**LANCASTER COUNTY PLANNING COMMISSION
 County Council Chambers, County Administration
 Building, 101 North Main Street, Lancaster, SC 29720**

AGENDA

Subject: **The Sands at Kershaw – 20222205**
 Response to Preliminary Plat - 1st Review Comments

SHEET NO.: **C-106**

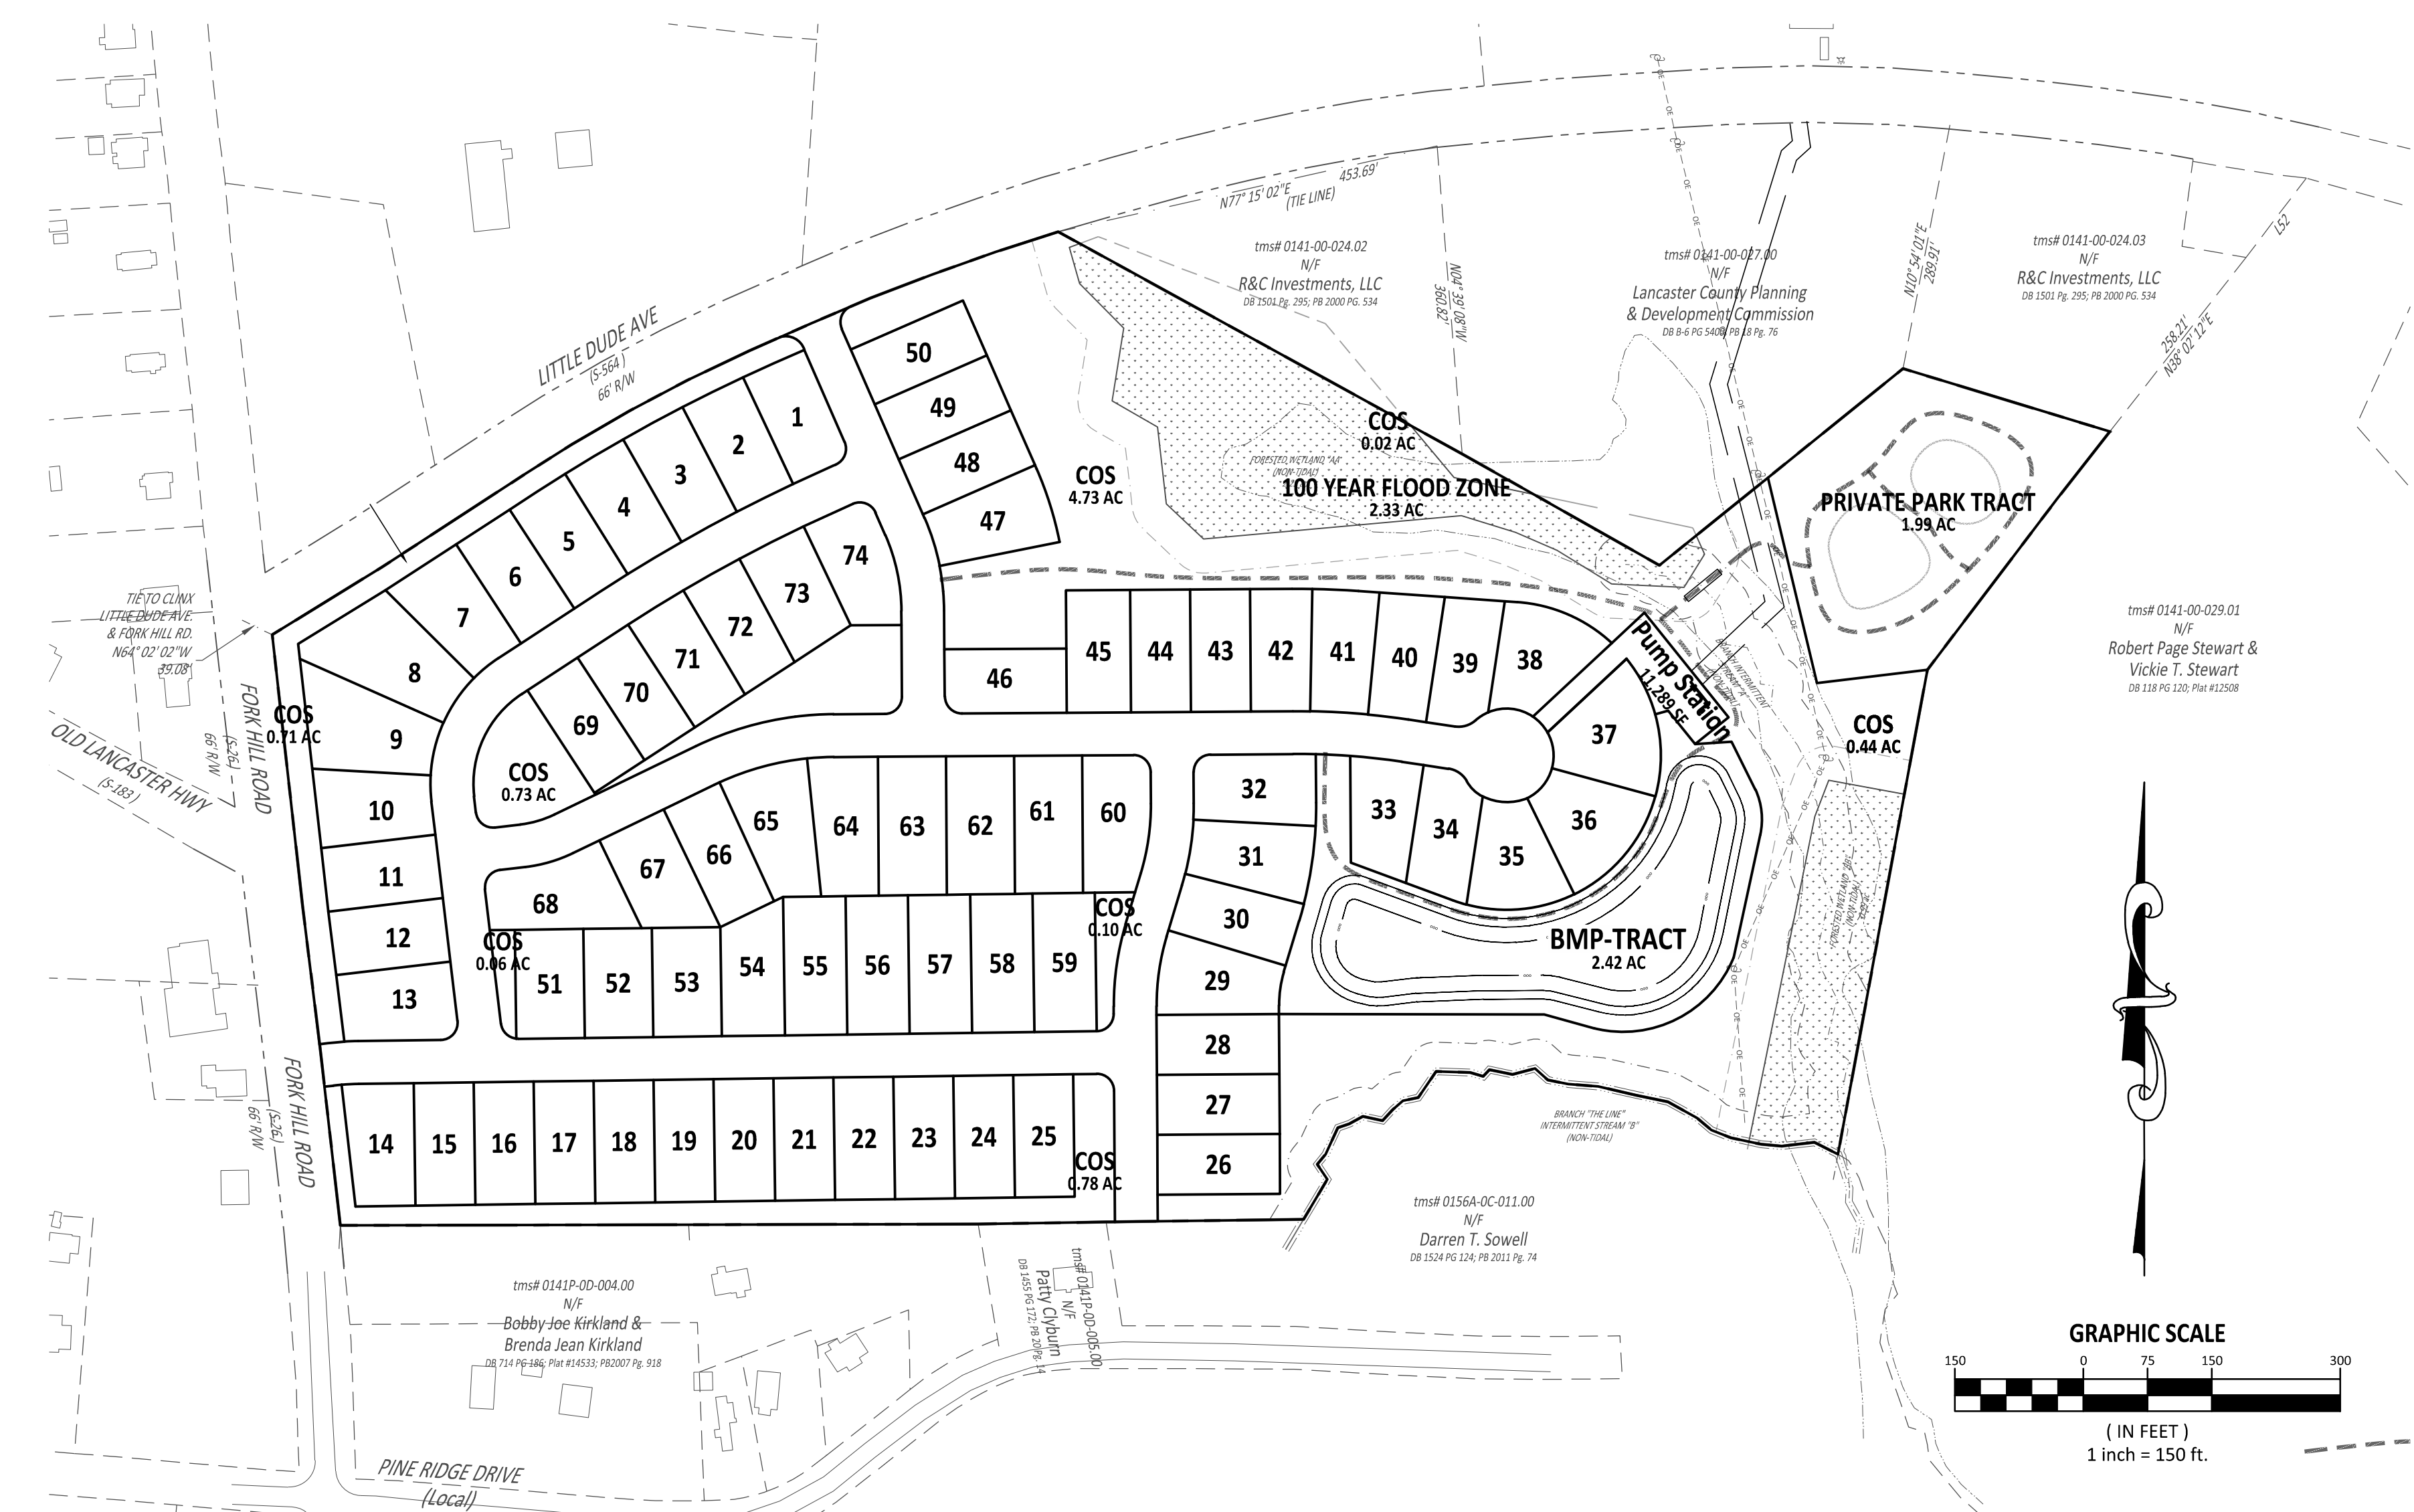
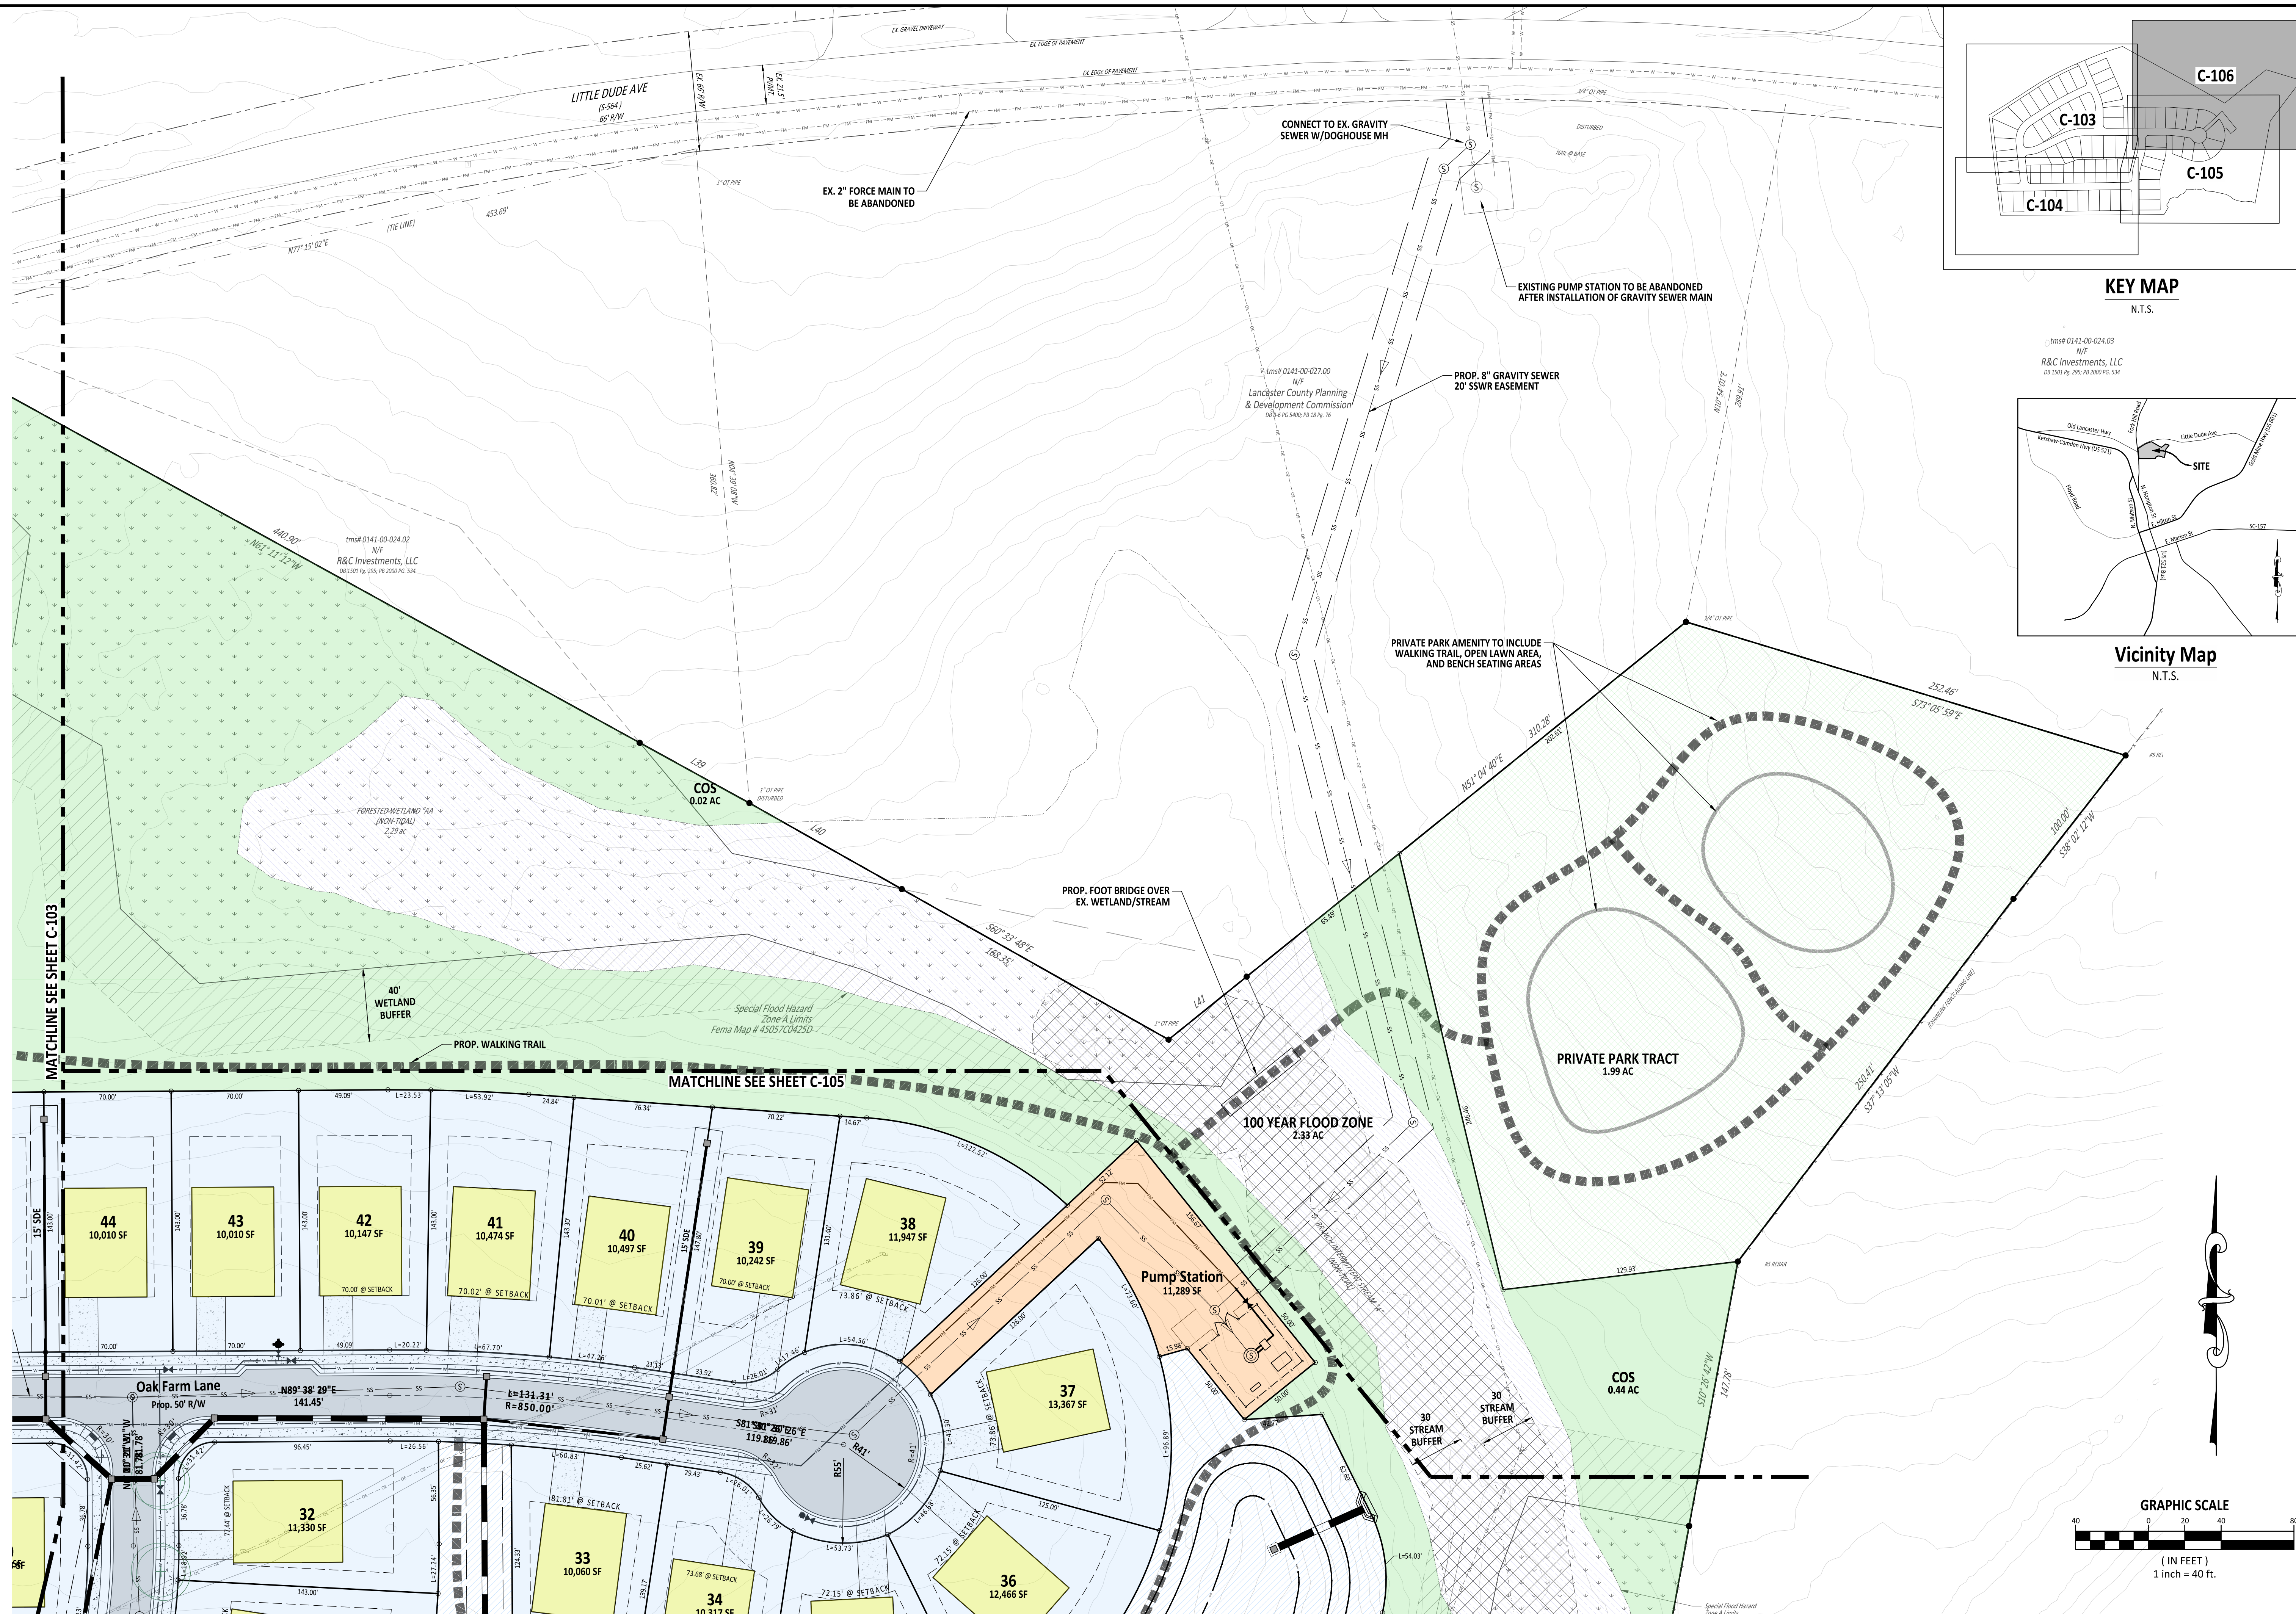
Response: Noted
2. The preliminary nature of the plan set provided does not provide adequate detail to formally comment, but the following are general items of note from the information given. More specific comments and additional subject matter will be commented on at the civil plan review phase.

Response: Noted
4. SCDOT was previously not in favor of the Fork Hill Road location as it does not meet their separation requirements. We are not sure if you have worked out this arrangement with them since the latest sketch plan review, but separation from existing roadways on Fork Hill would seem to still be an issue.

Response: Noted
7. An 'A' Zone floodplain area bisects this parcel. Any disturbance or crossing of streams, stream buffers, and/or wetlands will need to be permitted through the US Army Corps of Engineers.

3. The common open space area cannot include areas within the floodplain. It is difficult to determine if the current open space calculations count the area within the floodplain. The open space areas must be buildable land. Please clarify this on next submittal

8. Show landscaping for required site landscaping areas (Street trees). Street Trees in the MDR zoning district are required at the rate of 1 Canopy Tree for every 40 feet of street frontage Spacing: Maximum of 50 feet on-center Location: In Planting Strip (5-foot minimum width). Further street tree requirements can be found in section 7.1.3 of the UDO.

Response: Bump outs for hydrants provided, and note added to typical lot detail on Overall Site Plan

Response: Common open space area & labels clarified

Response: Density provided in summary

Response: Sidewalks at said locations extended
